SUBJECT: F#2021-155370 LM Street Right-of-Way Encroachments of aerial 2nd floor balcony as well as amenity and lobby areas on floors 13-16.

Encroachment Agreement Application Transmittal Letter 307 E 2nd Street - SP-2021-0172C

RE: 307 E 2ND Street Case# SP-2021-0172C Encroachment Agreement

Encroachment Exhibit

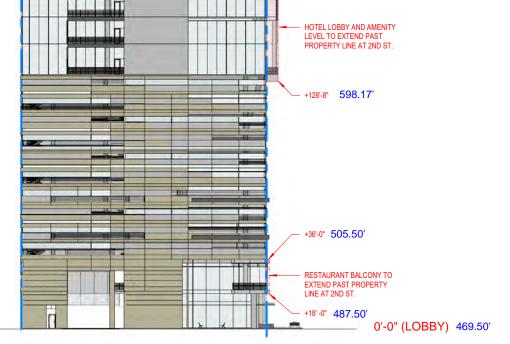
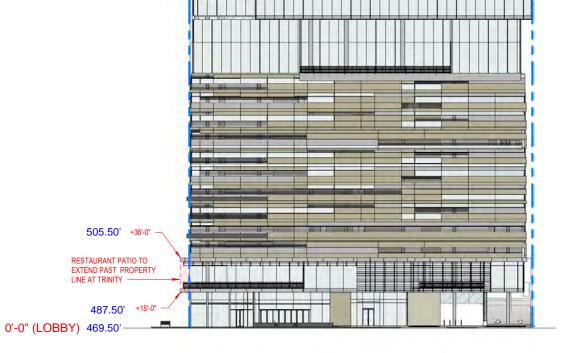
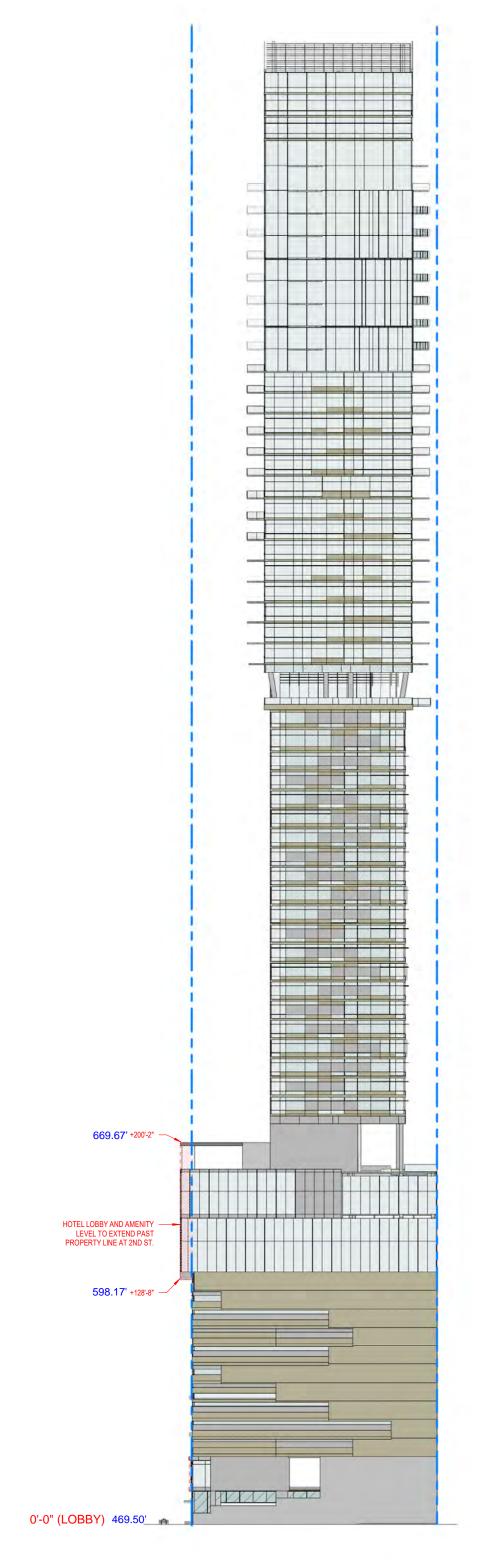
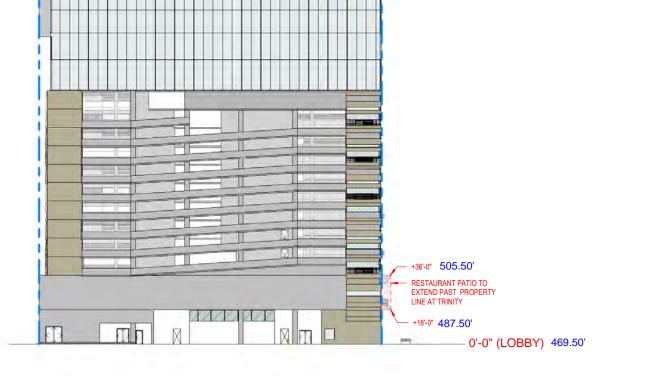
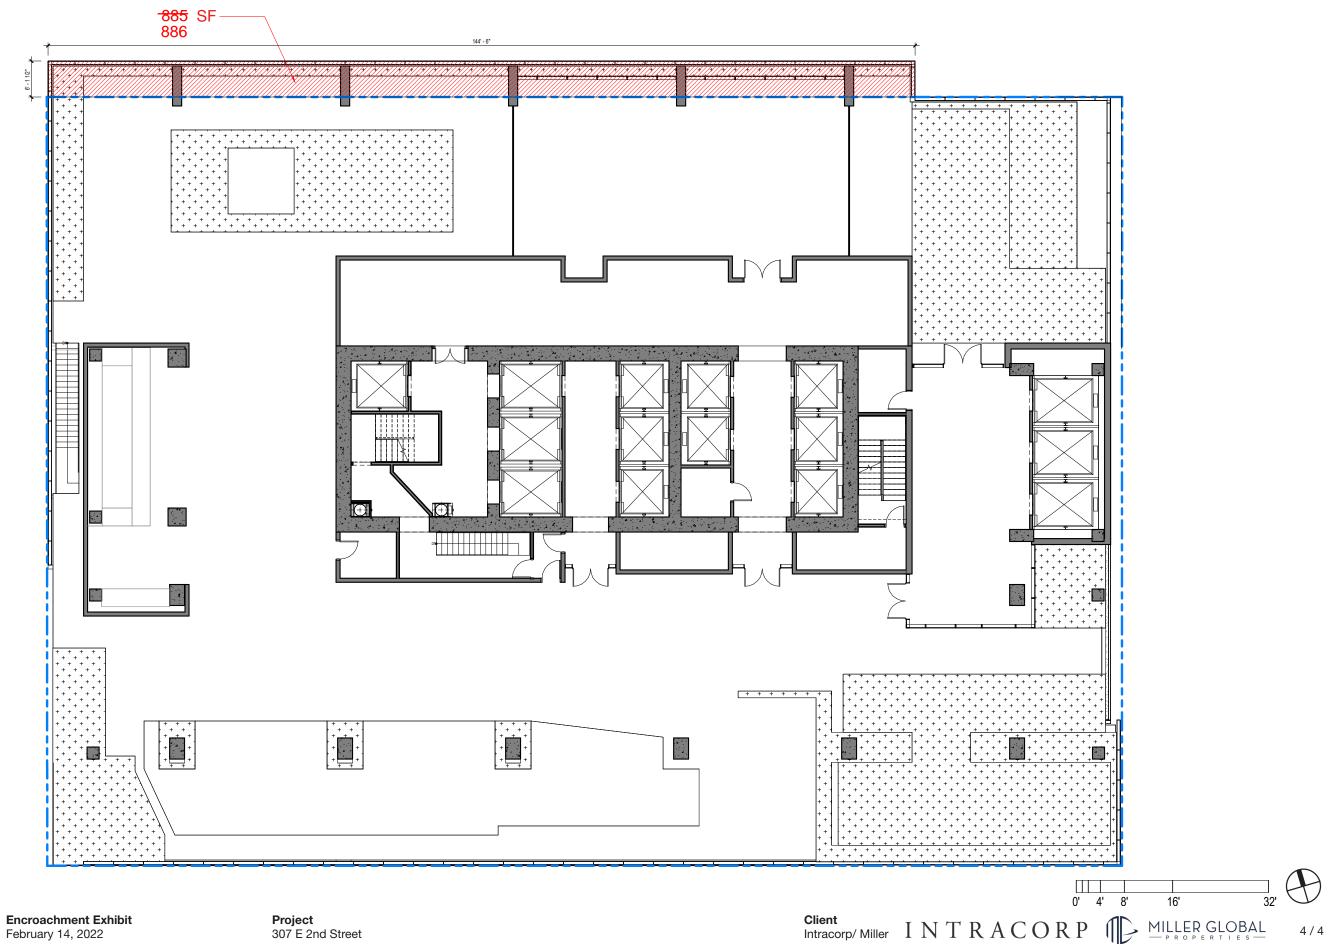
More information is needed to confirm actual ground elevation and the bottom floor elevation closest to ground elevation to ensure AW will have a minimum of 17-feet vertical clearance from ground to bottom of encroachment over right-of-way. Applicant is to provide a new survey or cross-section showing actual ground elevation and bottom elevation to closest encroachment of ROW. The statement at the top of the exhibits provided that states ?Elevations shown are based on an assumed elevation of 100.00? at the finished floor of the main lobby? is not sufficient. The city needs proof of actual ground elevations and certified. Additionally, there is concerned about operation and maintenance of existing AW infrastructure in the area. AW is requesting applicant to provide a response on where equipment/materials will reside? And, if AW needs to access our water or wastewater lines, will equipment/materials be easy to move for City personnel to access? How close will the equipment be from the existing utilities?

BPBD1. ELEVATIONS: The elevations in this plan set do not indicate an accurate height. There are no dimensions on the (unstamped) drawings. Please indicate how the balconies over 8? and below 15? comply with 3202.3.2 in the 2021 IBC.

Response: Encroachment area has been revised, and the encroachment is not extending over AWU infrastructure. Actual ground elevation has been added in Blue to both he survey exhibits and the architectural exhibit. Bottom of the lower encroachemtn is 18' above ground.

Response: Elevations have been updated and dimensions have been provided.

0.0203 ACRE ENCROACHMENT AGREEMENT City of Austin, Travis County, Texas

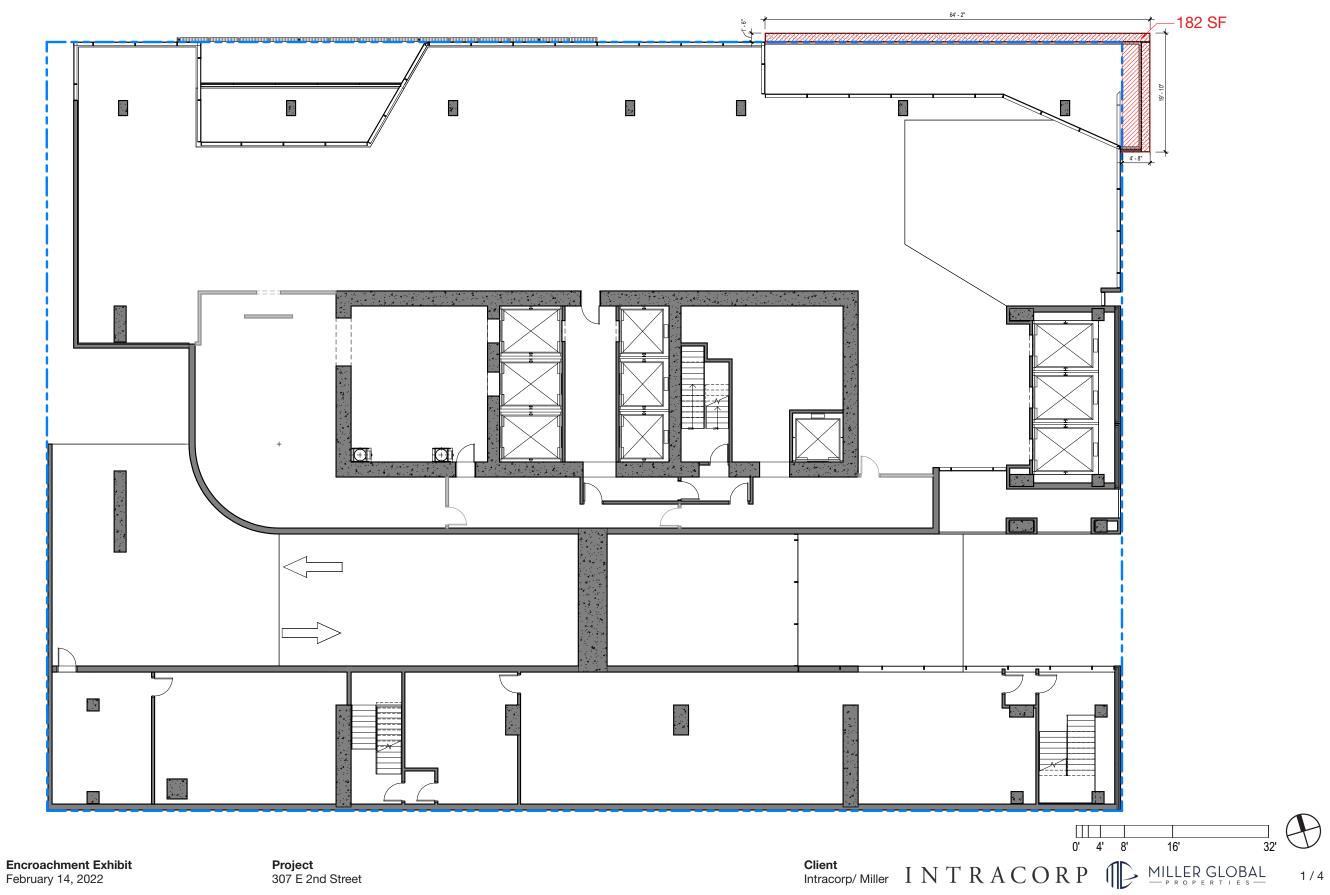
1. Restaurant Patio on 2nd floor creates conflict with street trees. There needs to 35 FT vertical clearance to allow proper growth of street trees.
